FINAL DRAINAGE REPORT ADDENDUM

ELLSWORTH ROAD
UNIVERSITY DRIVE TO MCLELLAN ROAD (PHASE II)

Maricopa County Project No. 68902

REVIEW COMMENT SHEET

Figure 5.27

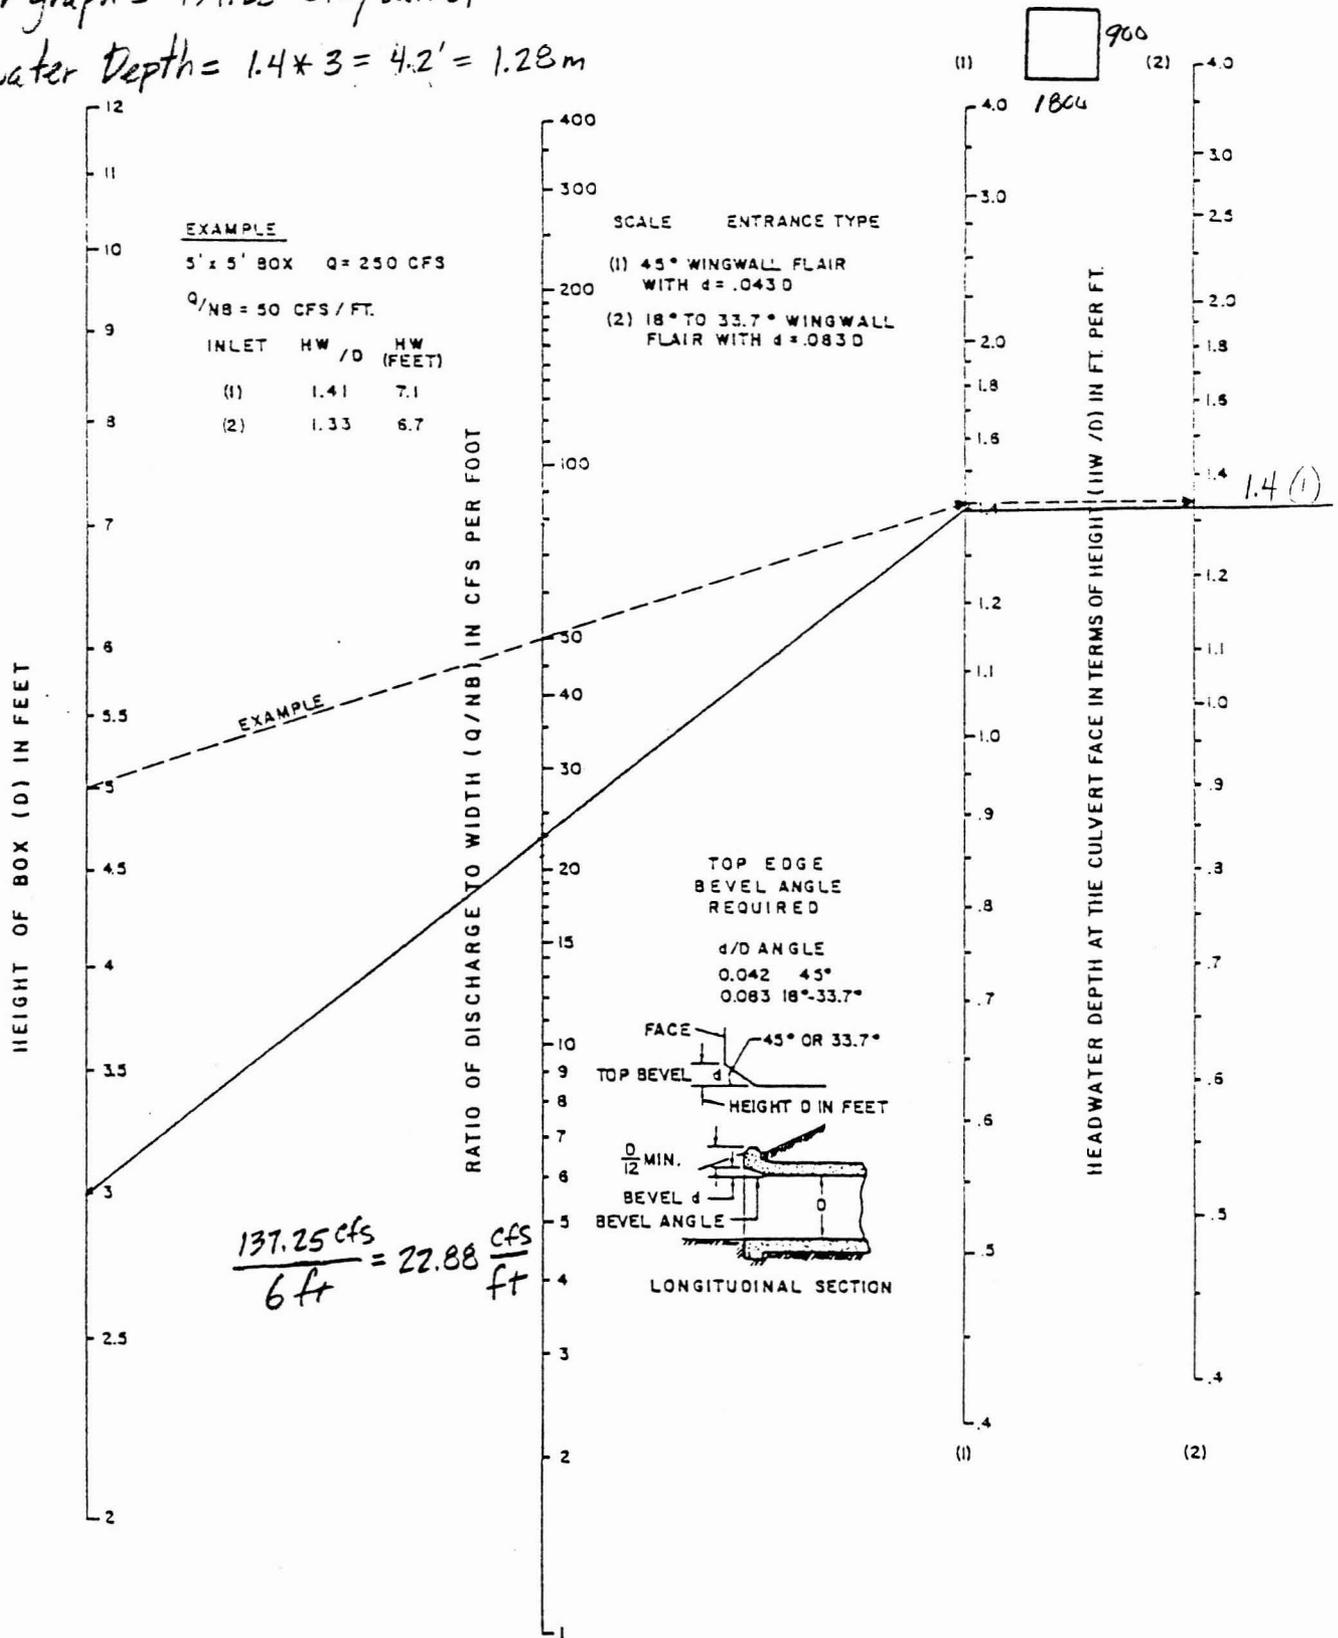
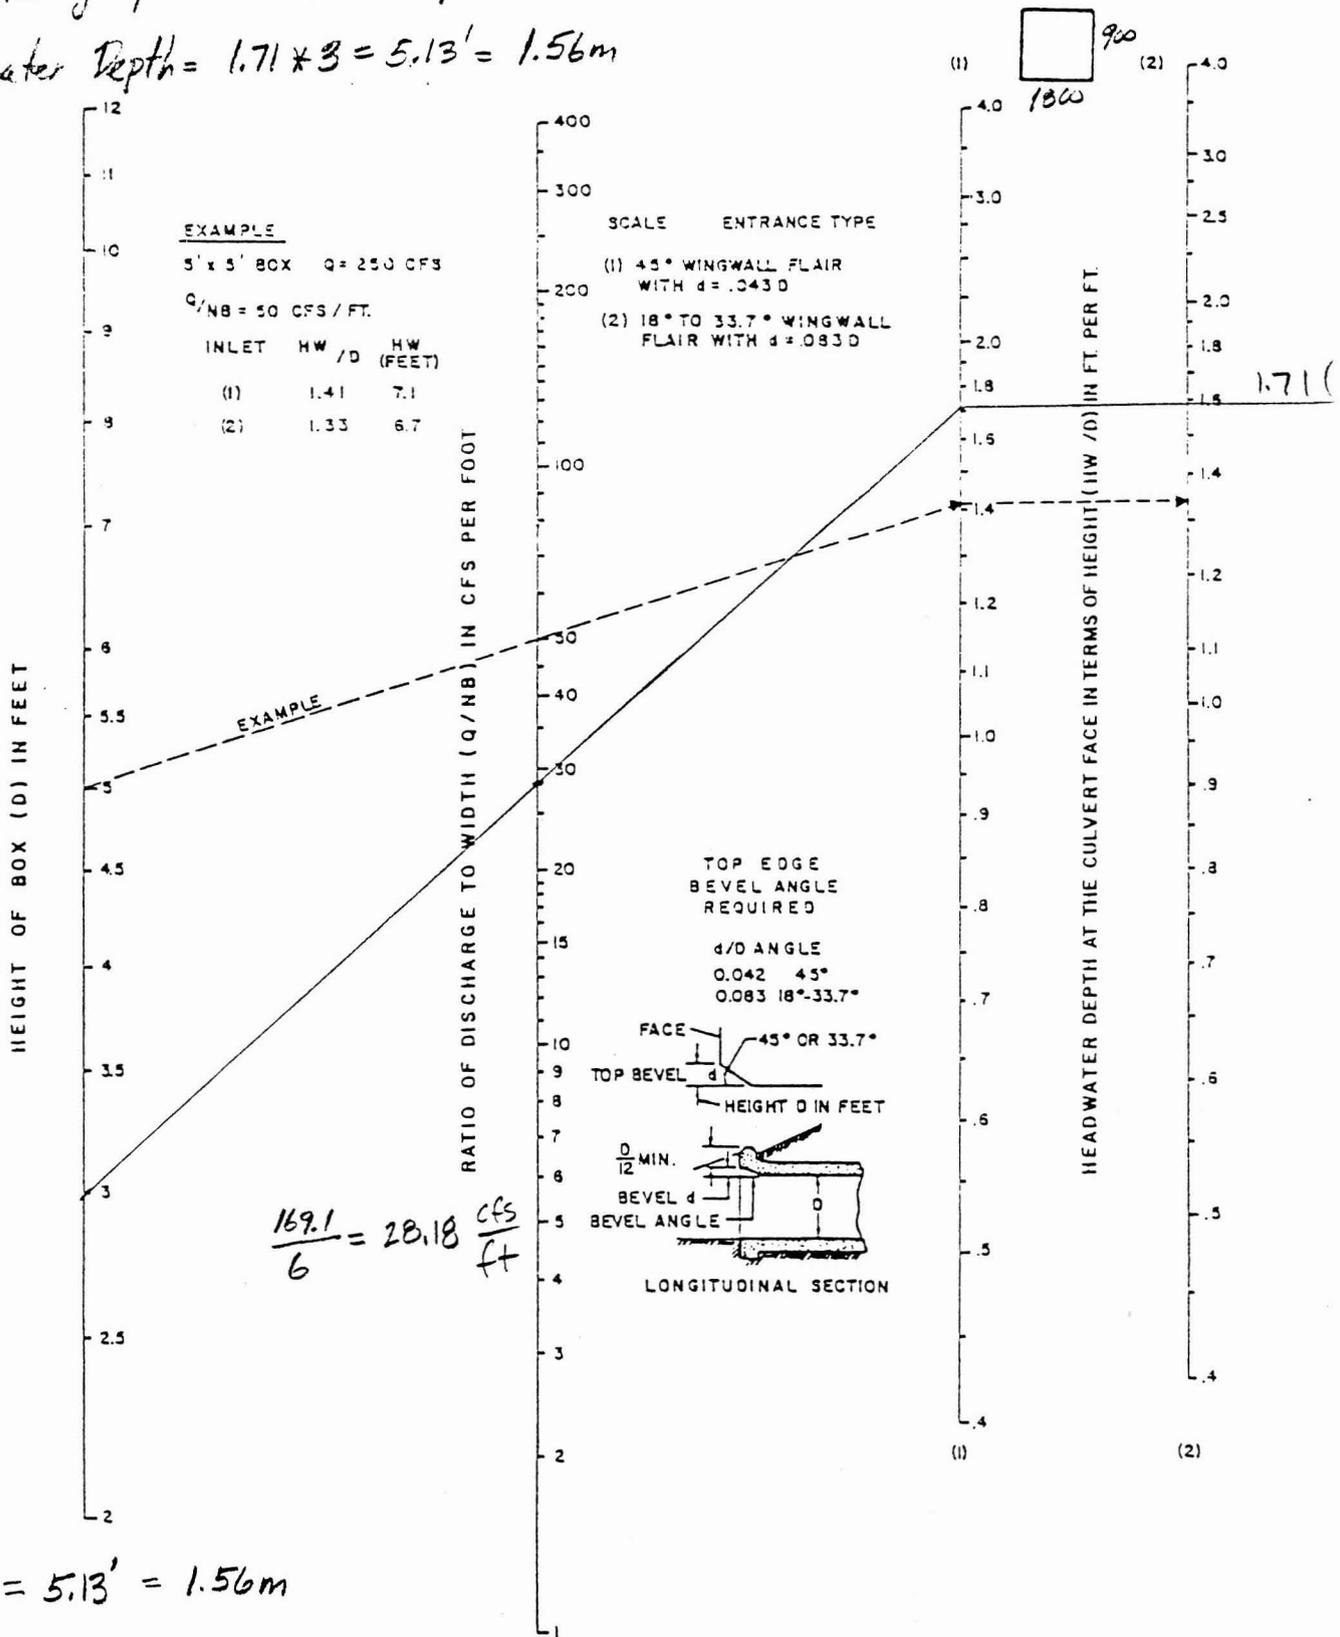
The box culvert inlet includes a drop with ADOT Standard B-04.30 inlet wings set 45 degrees to the construction centerline. Headwater elevations were calculated using the Maricopa County Drainage Design Manual, Volume II for the 50-year and 100-year events. The 50-year headwater elevation is 483.923 and the 100-year headwater elevation is 484.203. See attached Figure 5.27 for headwater depths.

50 yr $Q = 7.77 \text{ m}^3/\text{sec} = 274.5 \text{ cfs}$

Flow for graph = $137.25 \text{ cfs}/\text{barrel}$

Headwater Depth = $1.4 \times 3 = 4.2' = 1.28 \text{ m}$

$100\text{ yr } Q = 9.57 \text{ m}^3/\text{sec} = 338.1 \text{ cfs}$
 Flow for graph = $169.1 \text{ cfs}/\text{barrel}$
 Headwater Depth = $1.71 * 3 = 5.13' = 1.56\text{m}$

Figure 5.31
Headwater Depth for Oval Concrete Pipe Culverts
Long Axis Horizontal with Inlet Control
(USDOT, FHWA, HDS-5, 1985)

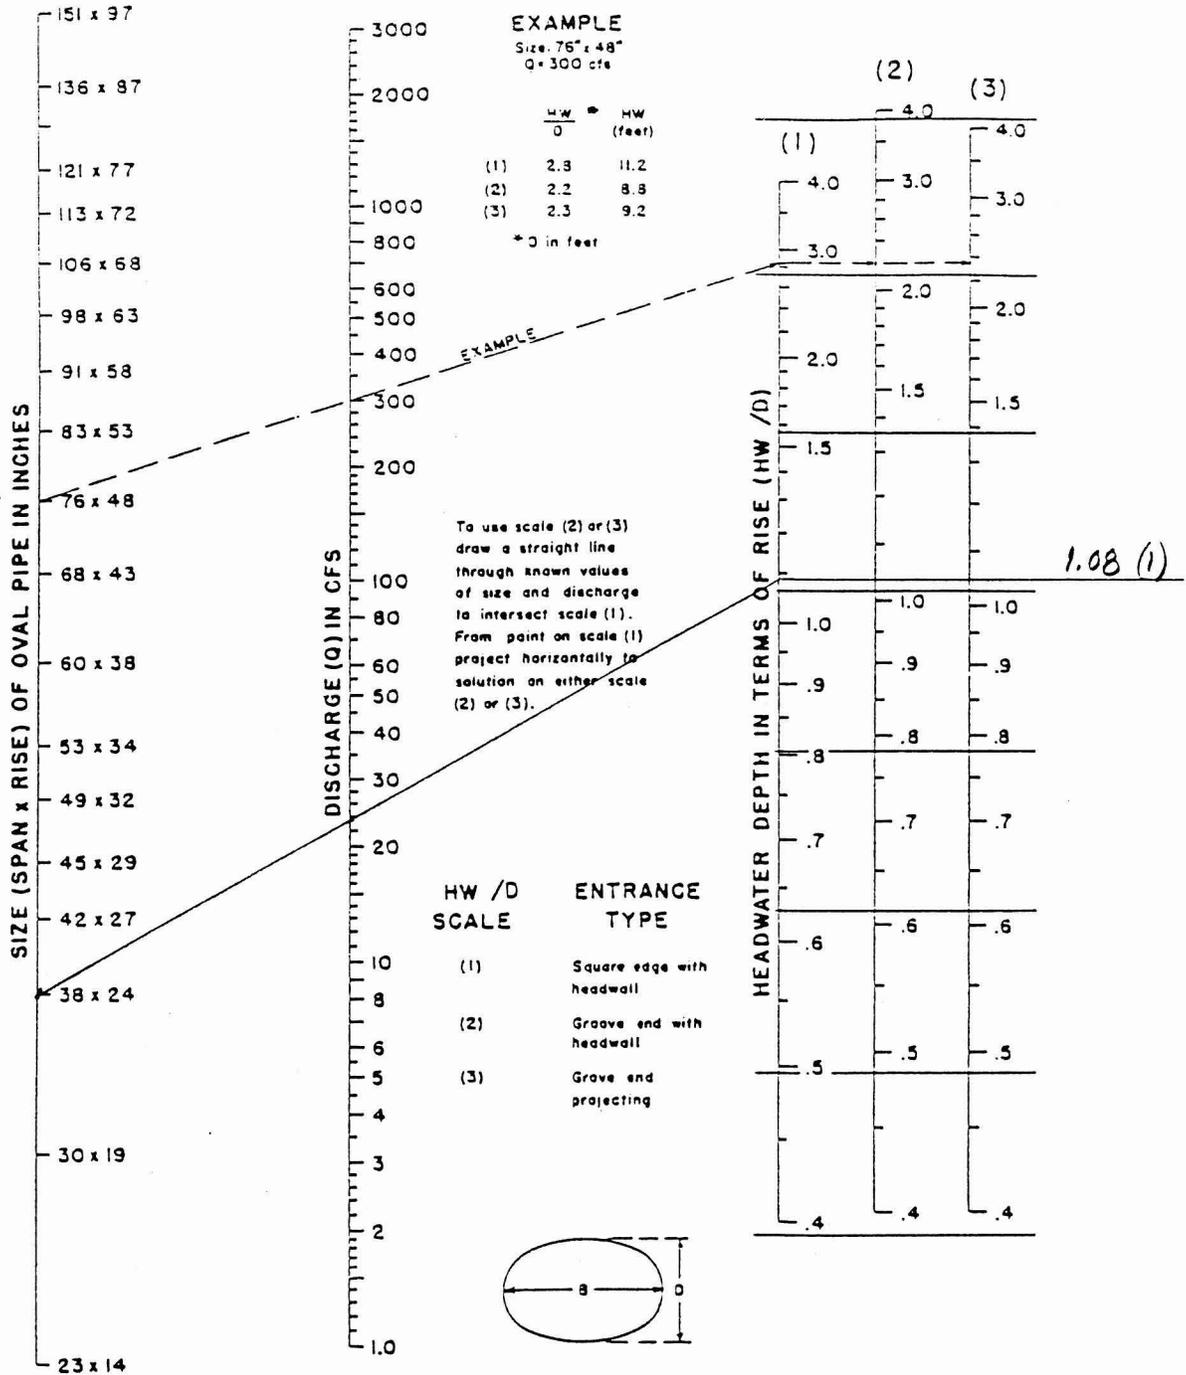
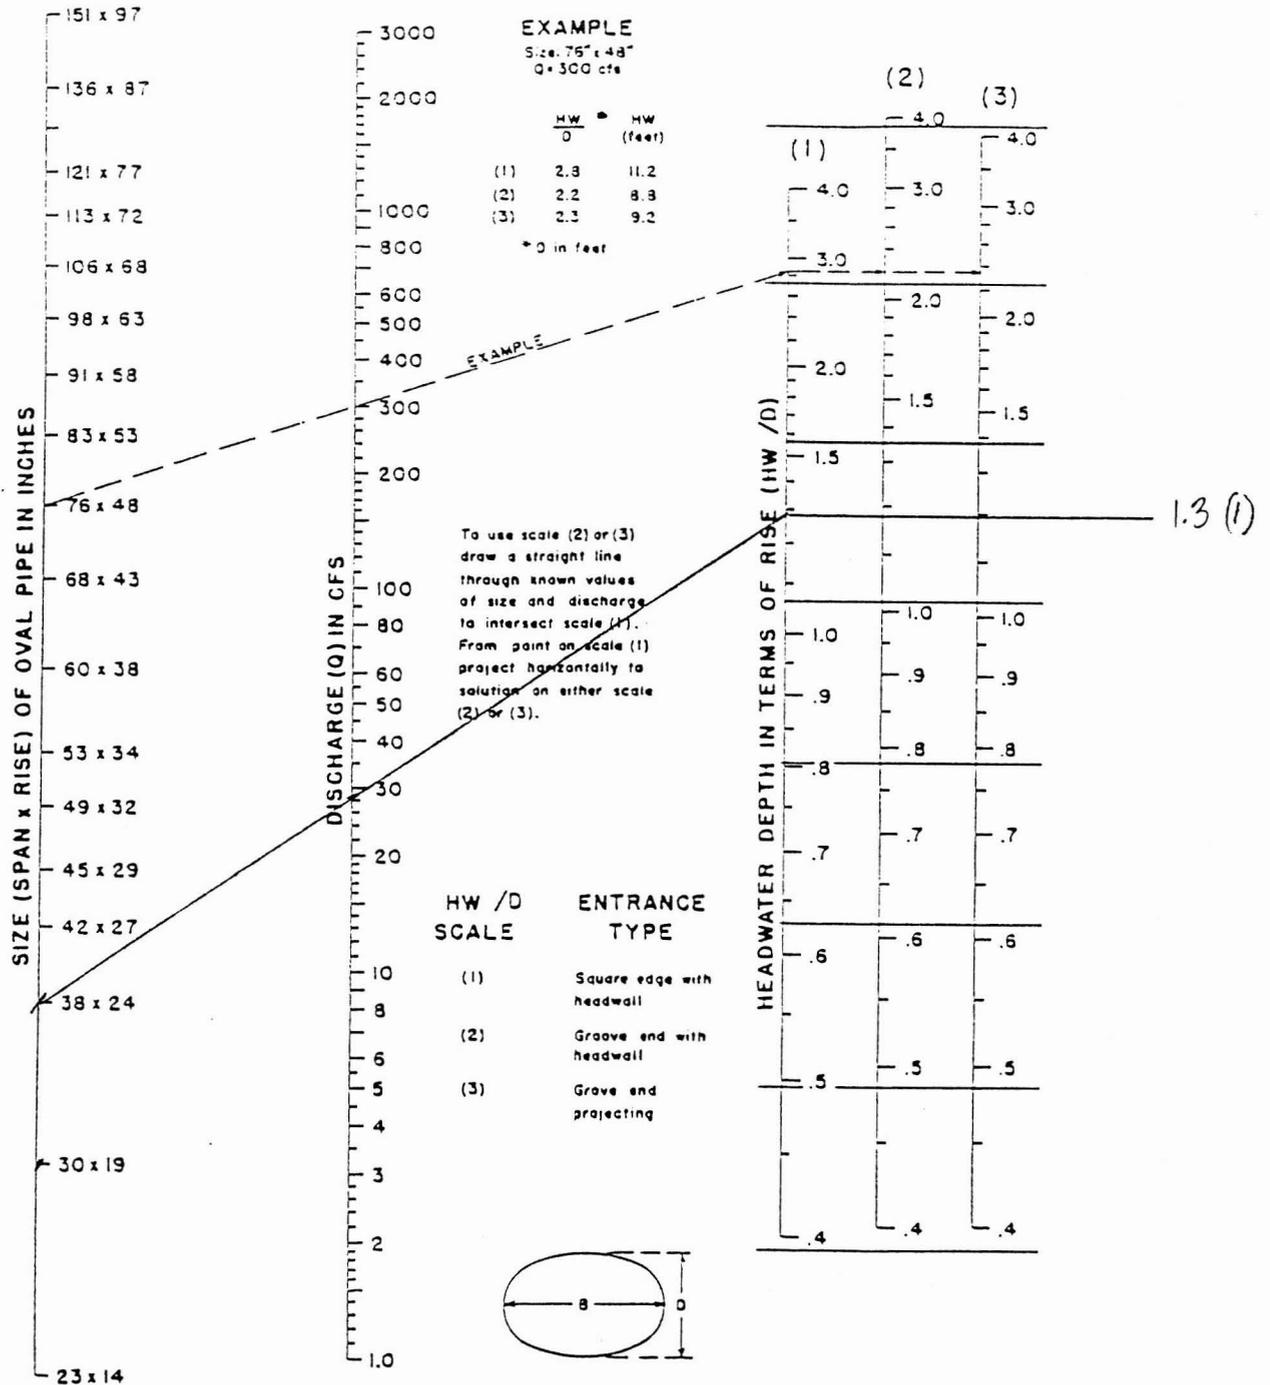
Headwater depths were completed using the Maricopa County Drainage Design Manual, Volume II for the elliptical culverts located at Sta. 6+384. The 50-year headwater elevation is 489.547 and the 100-year headwater elevation is 489.679. The 100-year event does not overtop the road. See attached Figure 5.31 for headwater depths.

53 yr Q = 1.33 m³/sec = 47.0 cfs

Flow for graph = 23.5 cfs/barrel

Headwater Depth = 1.08 * $\frac{24}{12}$ = 2.16' = 0.658m

100 yr $Q = 1.61 \text{ m}^3/\text{sec} = 56.88 \text{ cfs}$

Flow per graph = $28.44 \text{ cfs}/\text{barrel}$

Headwater Depth = $1.3 \times \frac{24}{12} = 2.6' = 0.79 \text{ m}$
